Rosamond High Early College Campus Cafeteria Building
SOUTHERN KERN UNIFIED SCHOOL DISTRICT
F&M Project No. 2990
Bid Clarification No.2; Page 1 of 2

BID CLARIFICATION NO. 2
June 30, 2023

L2.01

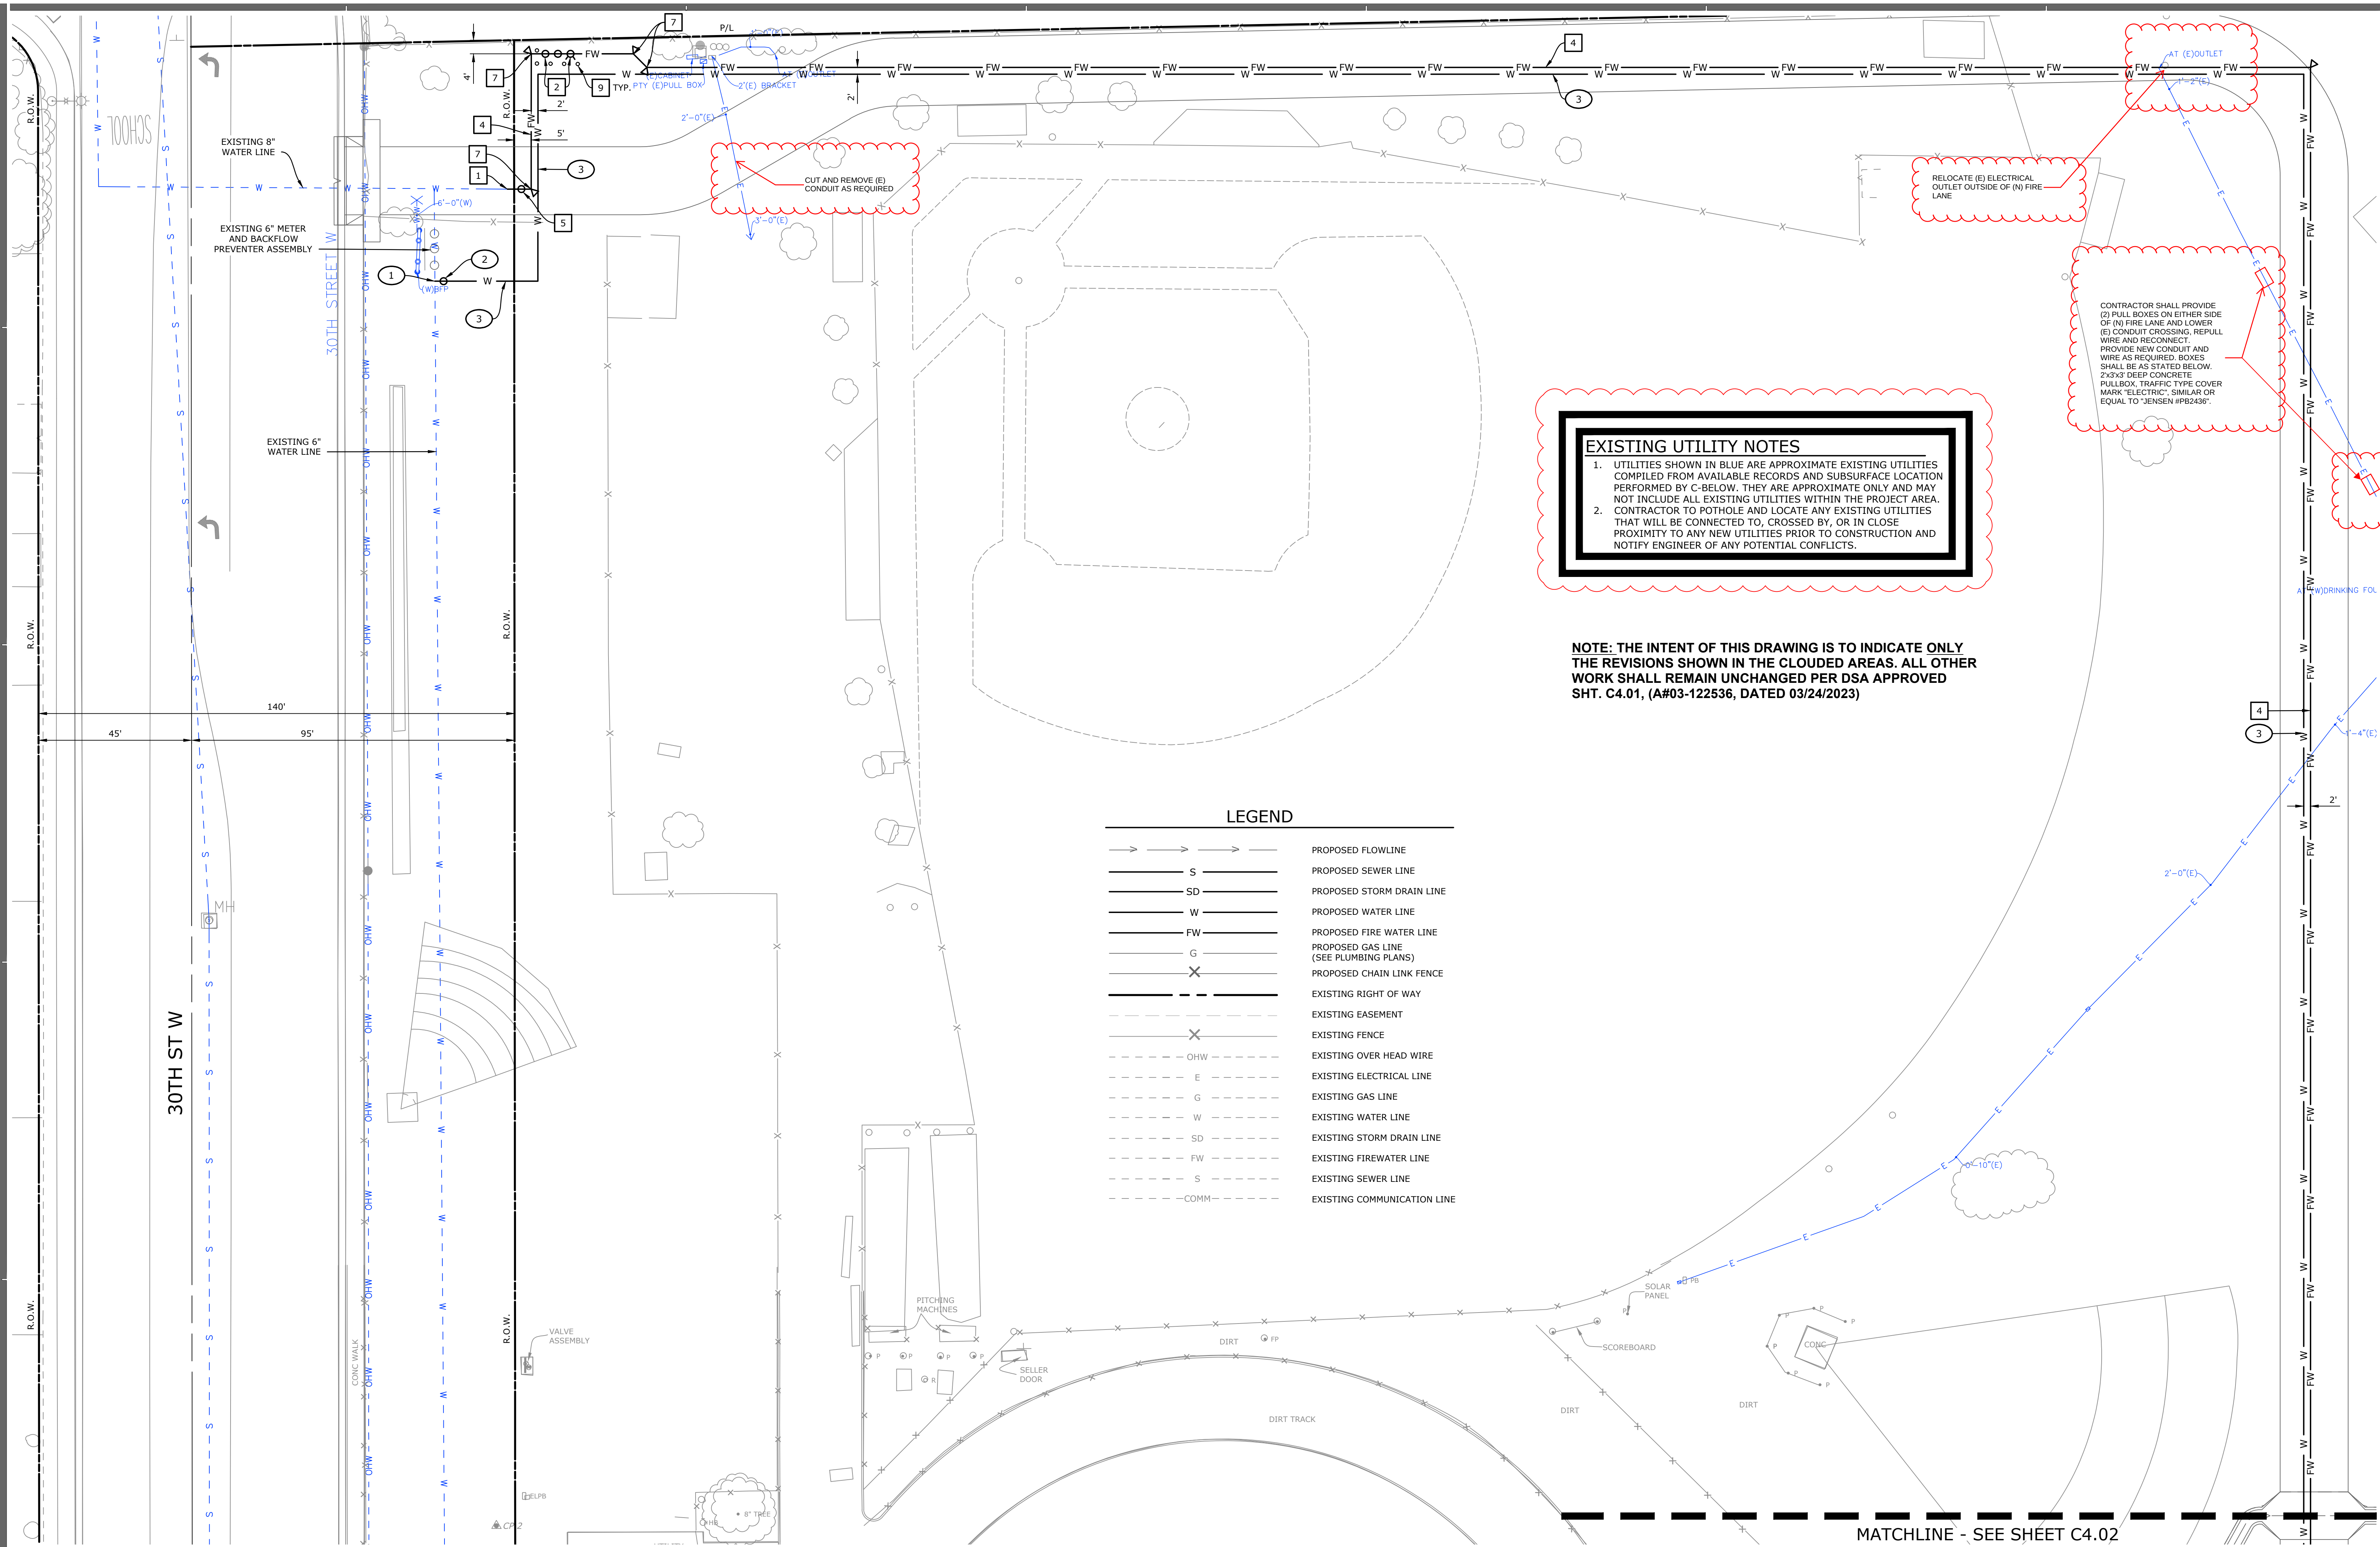
1. L2.01 – Irrigation Plan, “Bid Clarification No. 2”, with revision clouds as attached hereto.
2. C4.01 – Wet Utility Plan, “Bid Clarification No. 2”, with revision clouds as attached hereto.
3. C4.02 – Wet Utility Plan, “Bid Clarification No. 2”, with revision clouds as attached hereto.
4. C4.03 – Wet Utility Plan, “Bid Clarification No. 2”, with revision clouds as attached hereto.

C4.02

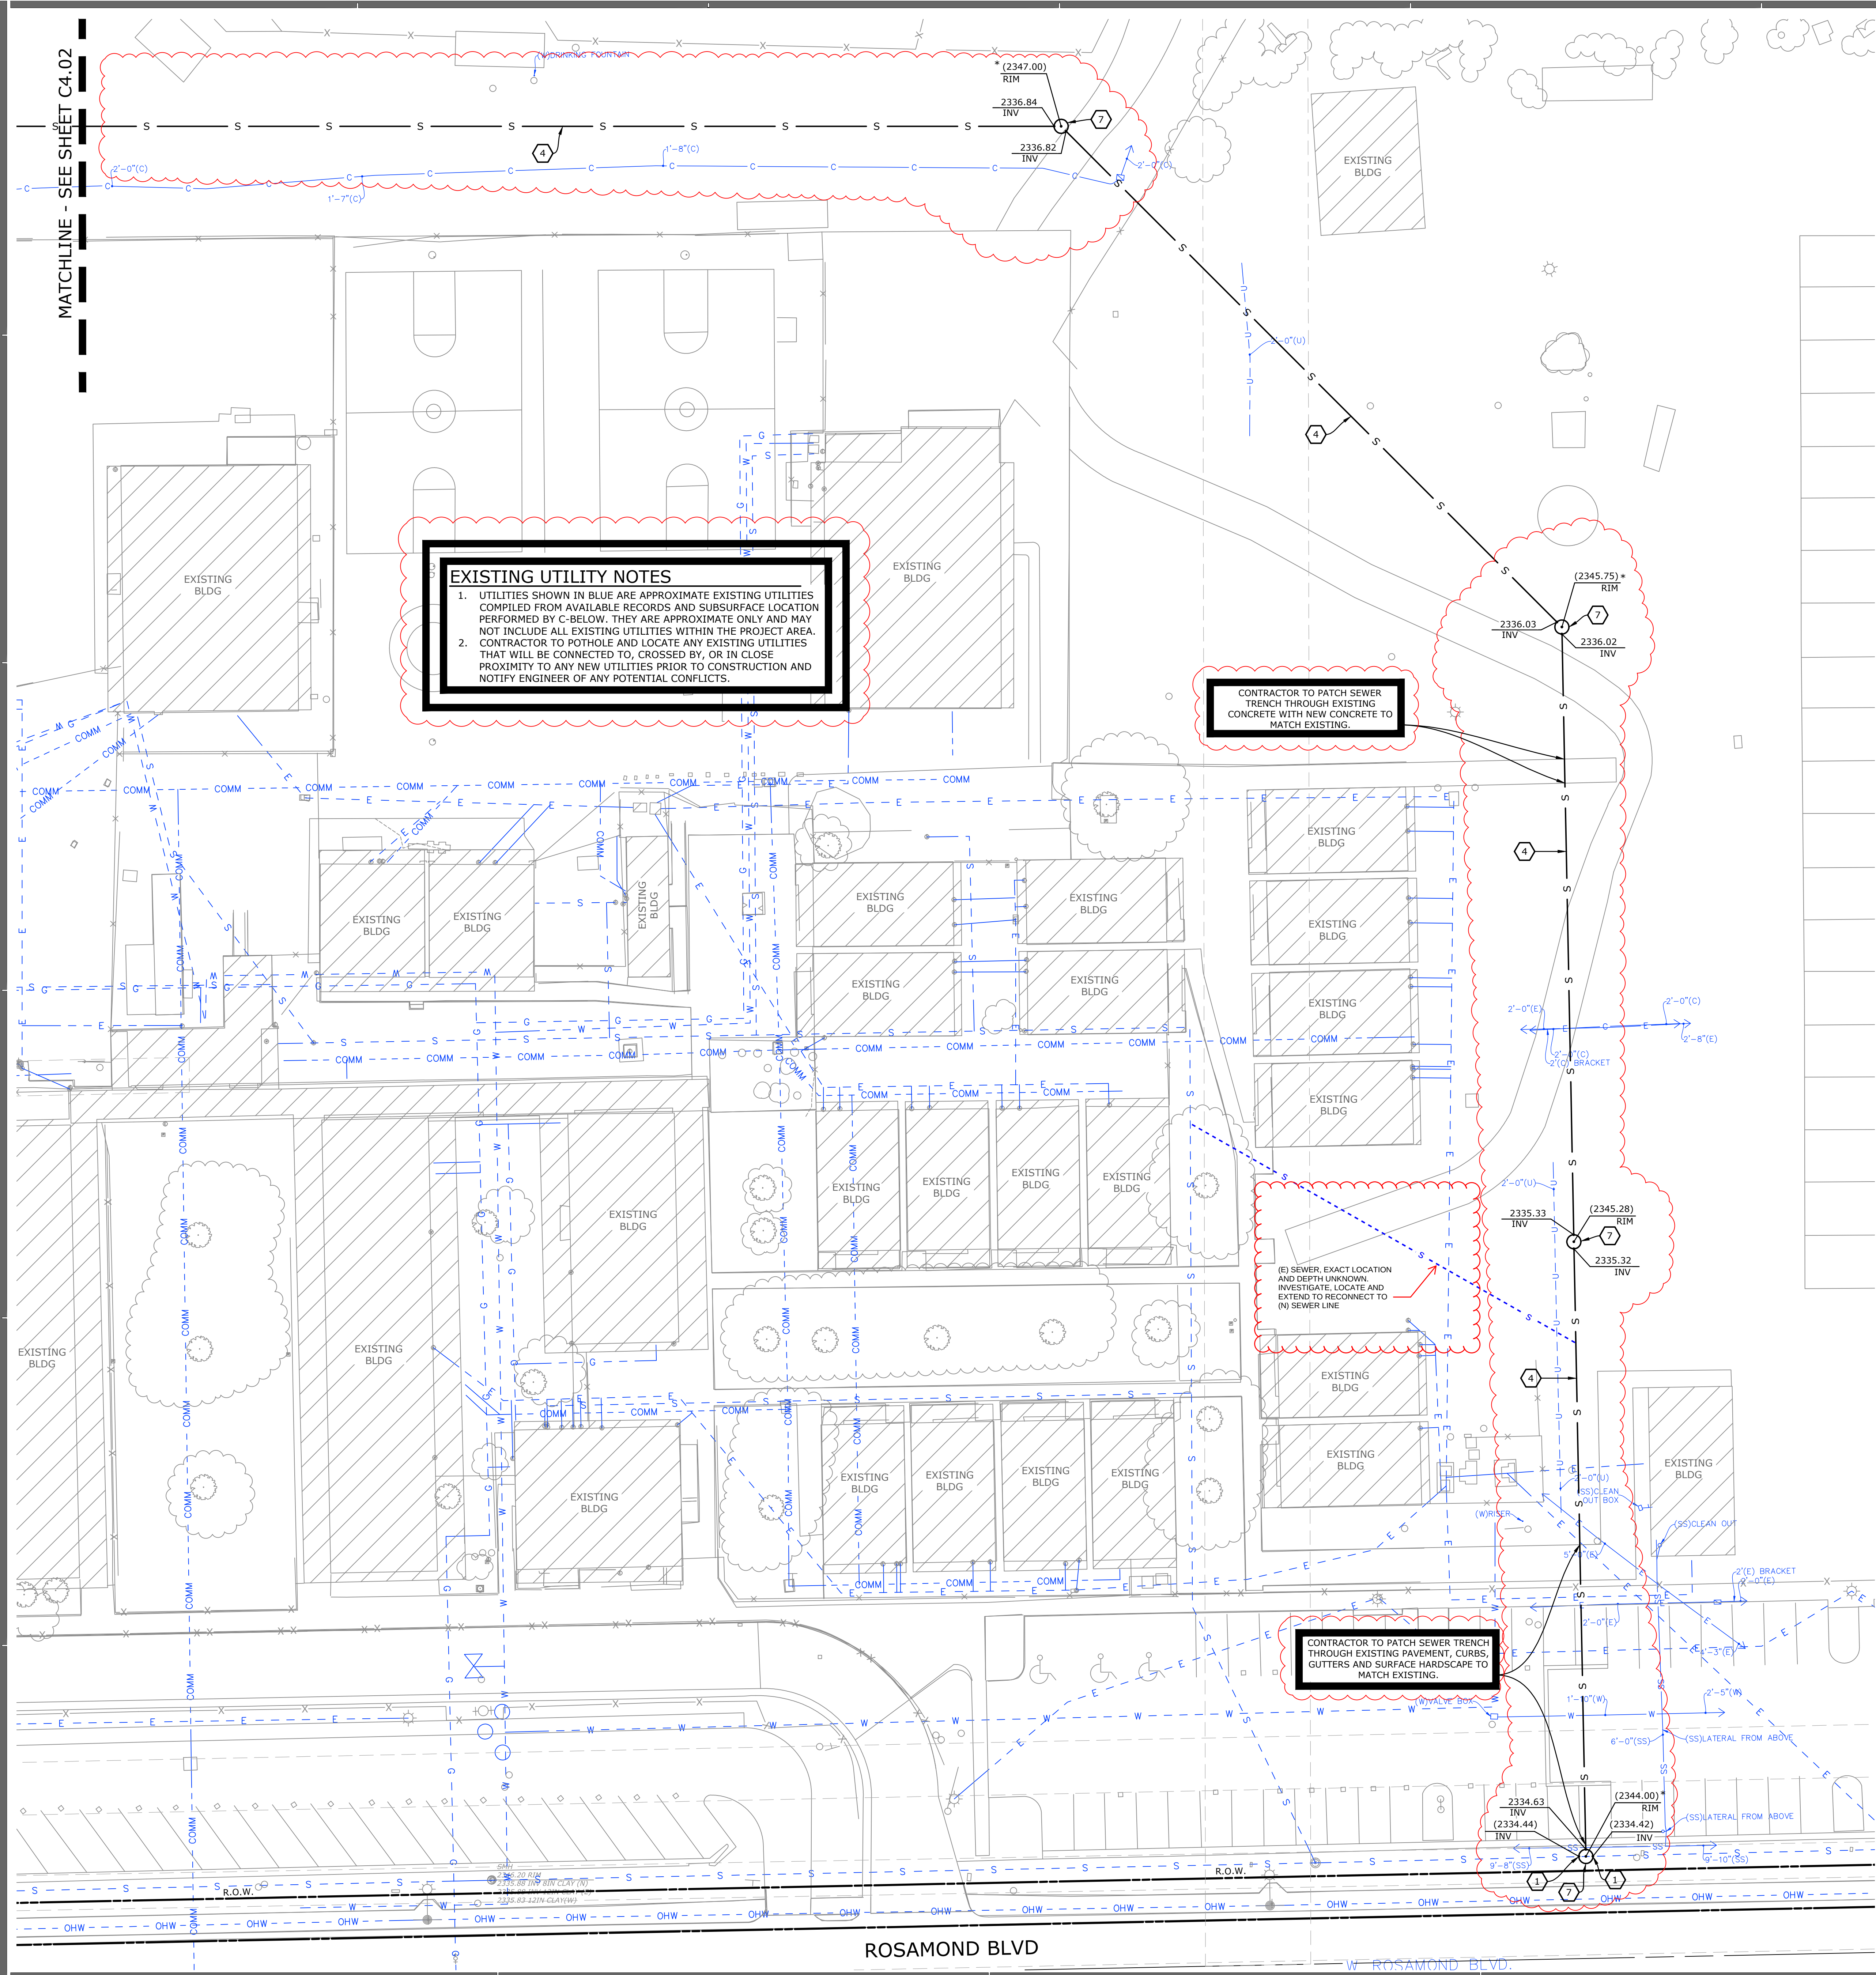
NOTE: THE INTENT OF THIS DRAWING IS TO INDICATE ONLY THE REVISIONS SHOWN IN THE CLOUDED AREAS. ALL OTHER WORK SHALL REMAIN UNCHANGED PER DSA APPROVED SHT. C4.02, (A#03-122536, DATED 03/24/2023)
